# UNITED STATES PATENT AND TRADEMARK OFFICE

APPLICATION NO.	FILING DATE	FIRST NAMED INVENTOR	ATTORNEY DOCKET NO.	CONFIRMATION NO.
10/088,645	04/18/2002	Joseph Crestin	P22017	7435

<b>Office Action Summary</b>	Application No. 10/088,645	Applicant(s) CRESTIN ET AL.	
	Examiner Aaron M Dunwoody	Art Unit 3679

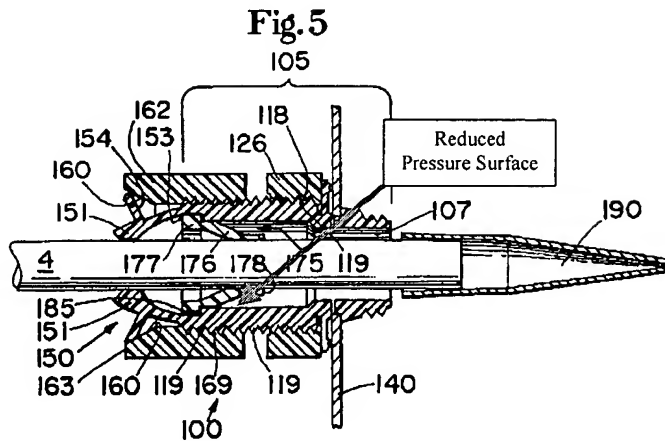
In regards to claim 1, Sheehan discloses a device for axial maintenance of a cylindrical element, comprising a coupling bushing (105) which is threaded externally (119) and which is prolonged in the axial direction by tightening nut strips (151), and a covering nut (162) comprising internally a reduced pressure surface (160) intended to act on the ends of the nut strips of the coupling bushing and to deform them radially towards the cylindrical element (4) previously introduced into the coupling bushing after crossing the nut, the device characterised in that it further comprises a sleeve (175) whose external diameter is at most equal to the internal diameter of the coupling bushing in which the sleeve is intended to be introduced beginning by the strips with which it is provided, the coupling bushing being further provided internally with a reduced pressure surface (see figure 5

below).
